ORIGINATION FORM

Proposed Revisions to a Standard Plans Index
(Please provide all information — Incomplete forms will be returned)

Index Number: 102-661
Sheet Number (s): 1 and 2 of 2
Index Title: Bicycle Lane Closures

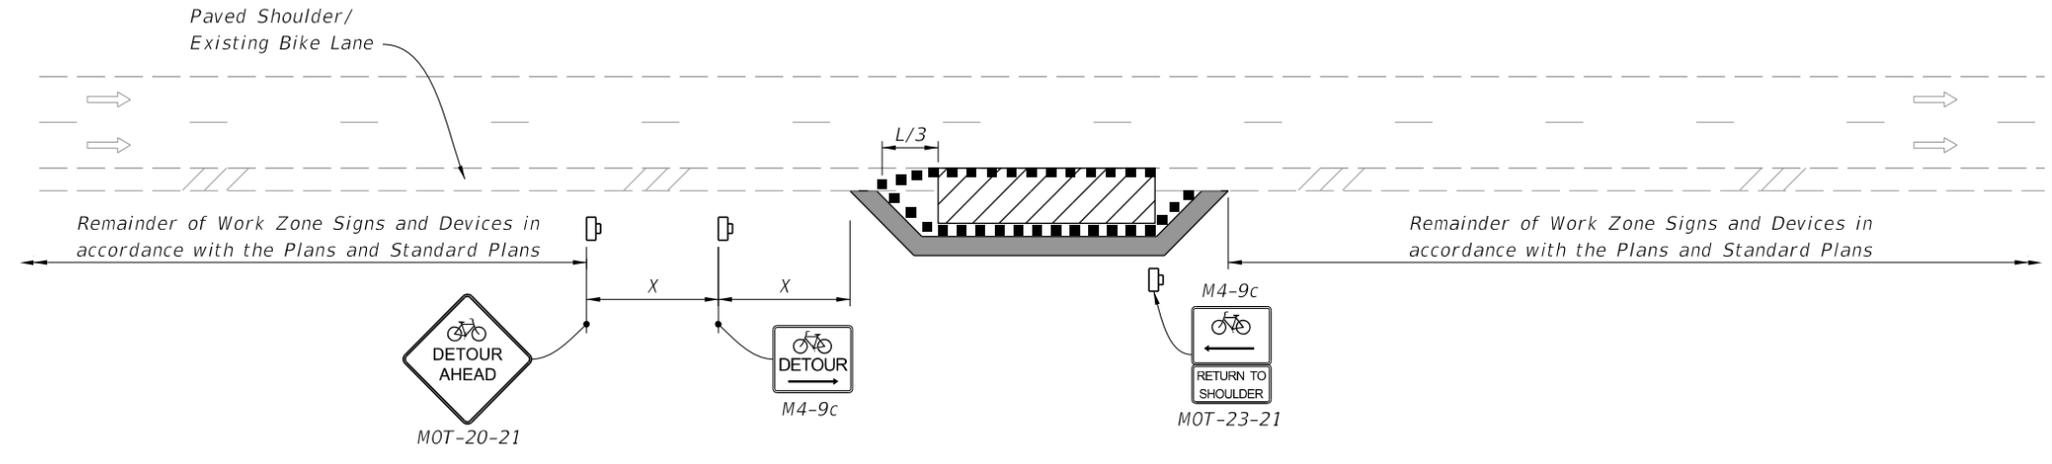
CHANGED TO: operation

CHANGED TO: FACILITY

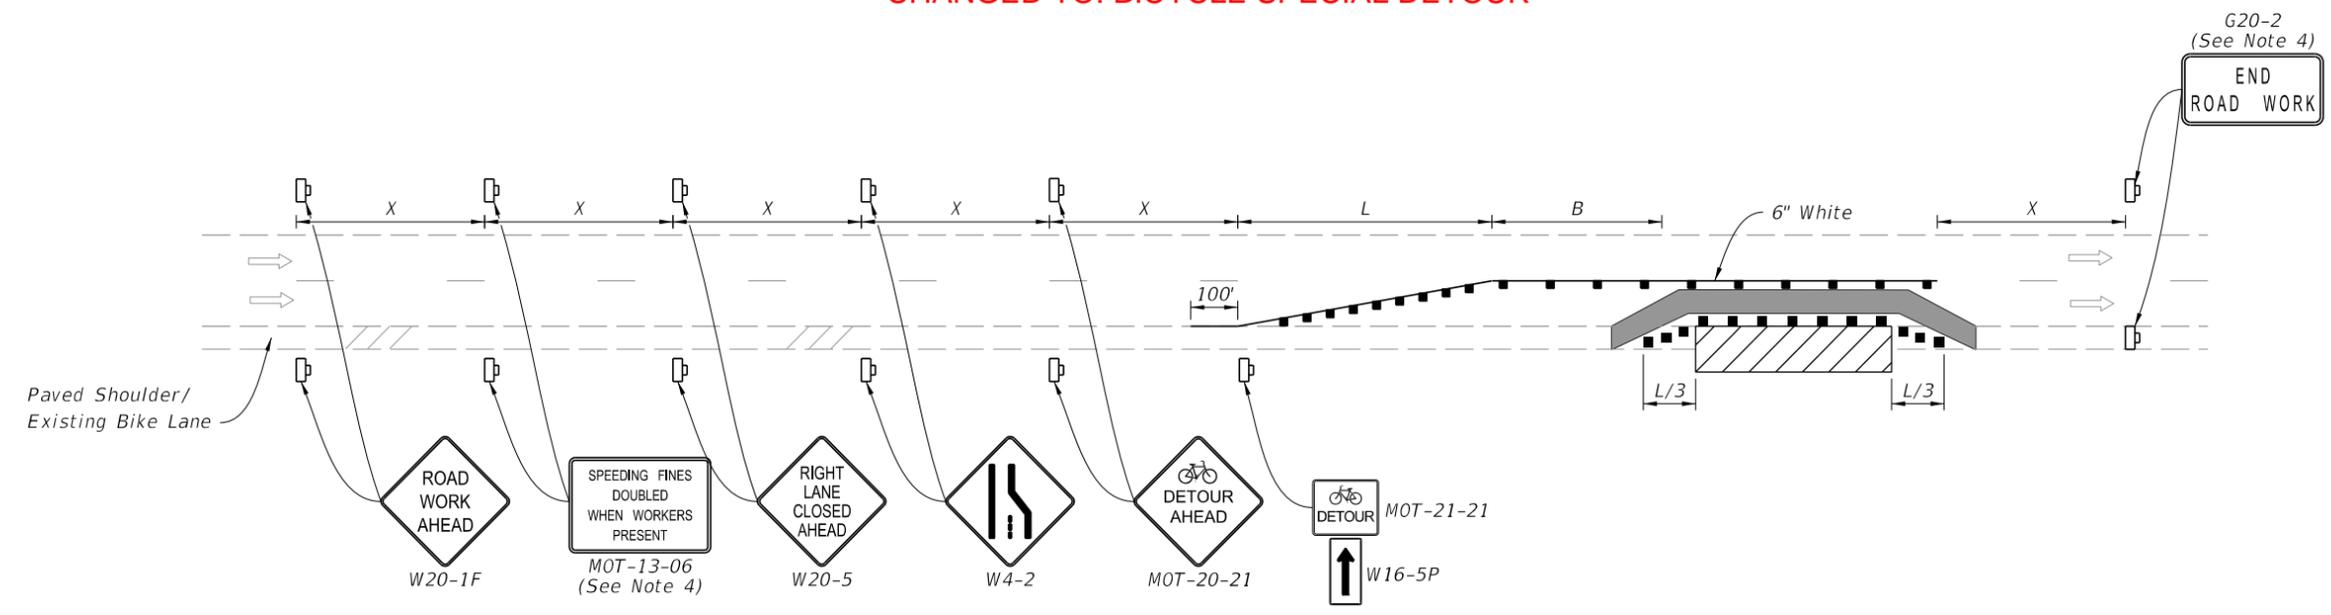
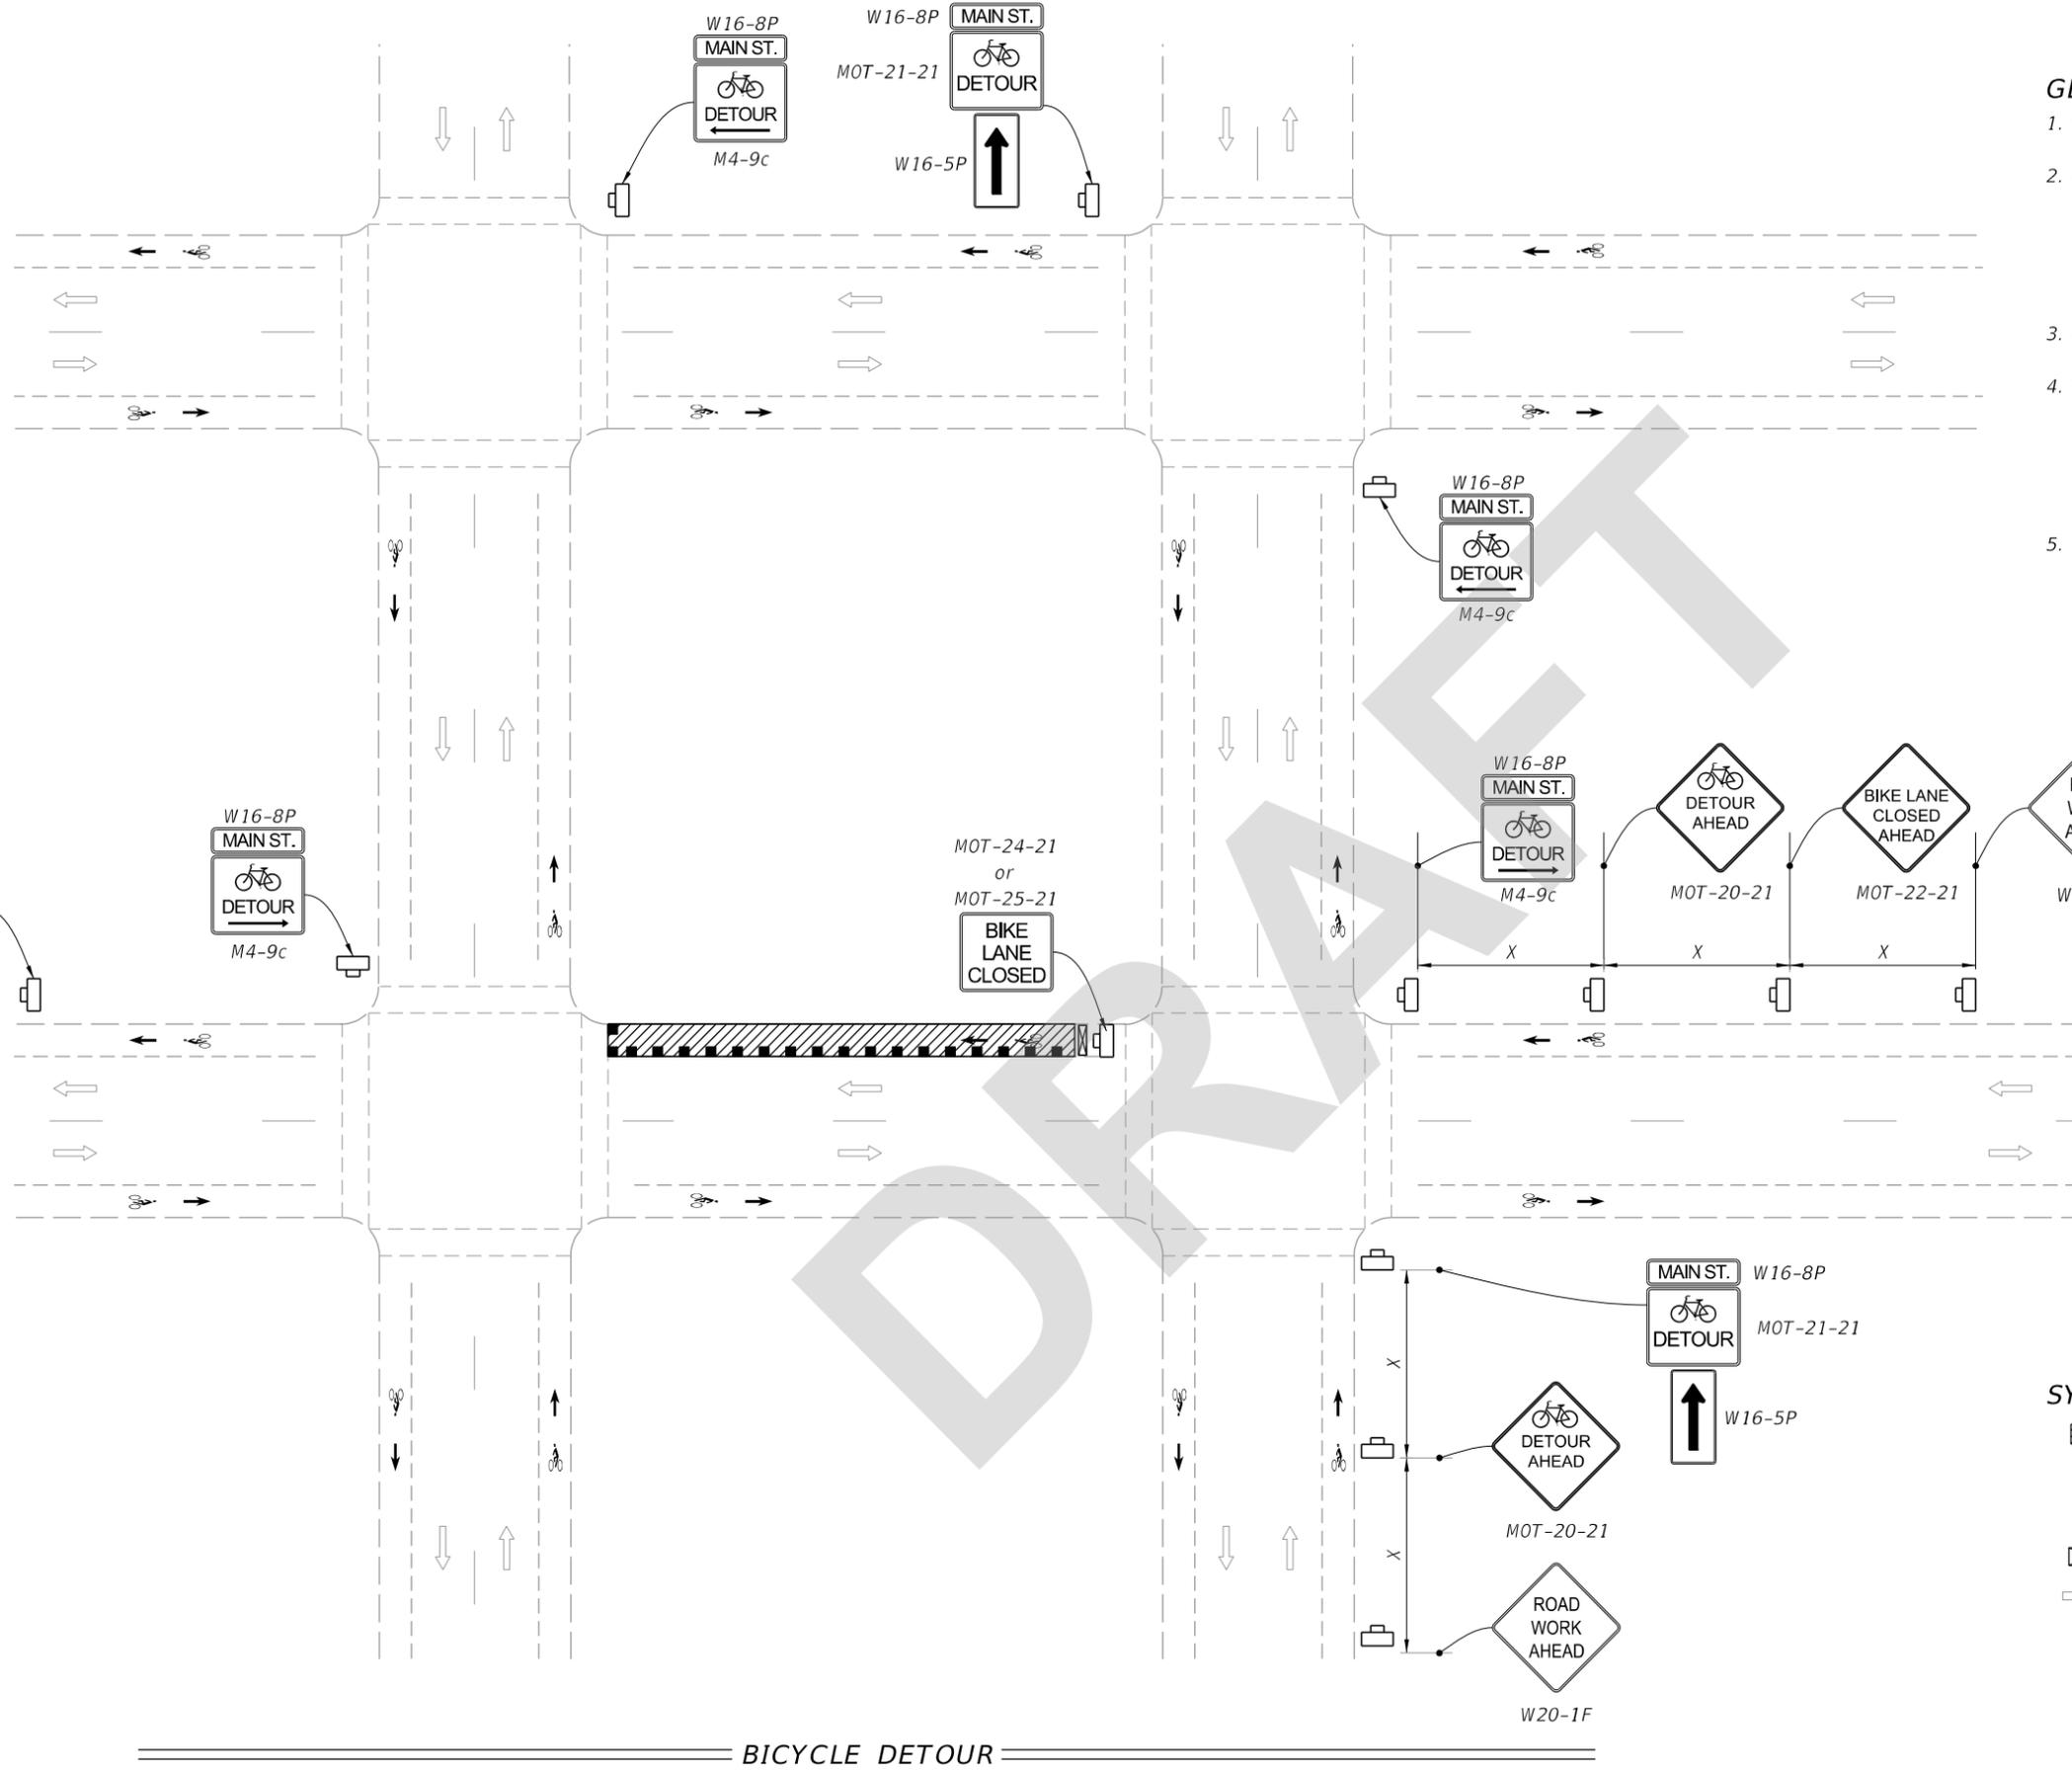
~~TEMPORARY BICYCLE DIVERSION~~
CHANGED TO: BICYCLE SPECIAL DETOUR

~~TEMPORARY BICYCLE WAY DIVERTING TRAFFIC INTO THE TRAVELED WAY~~
CHANGED TO: BICYCLE FACILITY SHIFT (With Lane Closure)

ADDED: Notes

Added Typical PCMS Display

ADDED: BICYCLE FACILITY SHIFT (Work Zone Speed of 35 mph or Less Detail)

**BICYCLE FACILITY SHIFT
(With Lane Closure)**

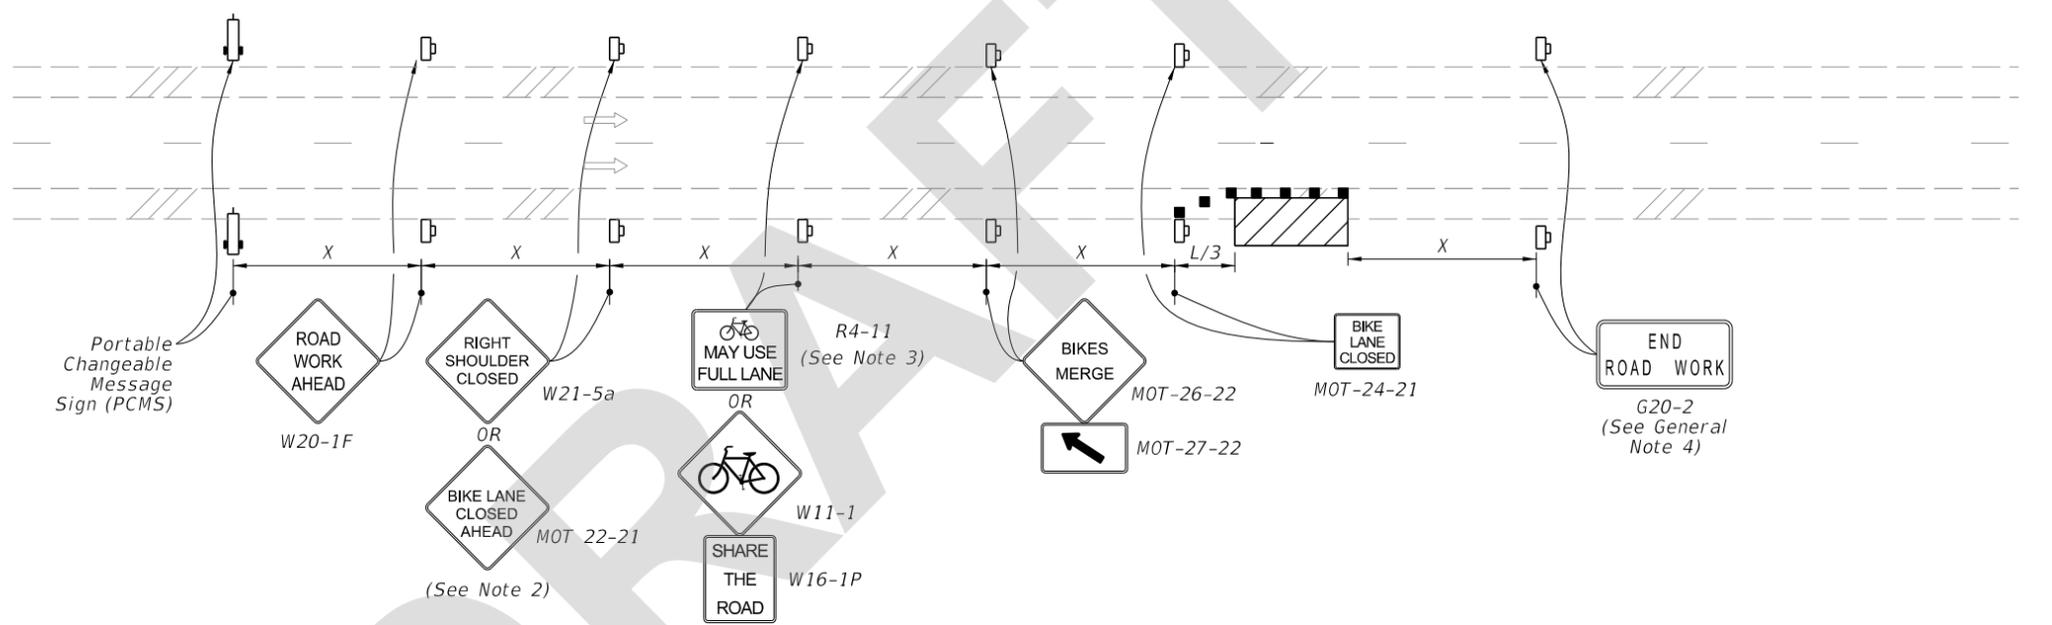
Sheet 2: Added Notes; Updated Symbols; Added Typical PCMS Display; Changed TEMPORARY BICYCLE DIVERSION to "BICYCLE SPECIAL DETOUR" and TEMPORARY BICYCLE WAY DIVERTING TRAFFIC INTO THE TRAVELED WAY to "BICYCLE FACILITY SHIFT (With Lane Closure)"; Added "BICYCLE FACILITY SHIFT (Work Zone Speed of 35 mph or Less)"
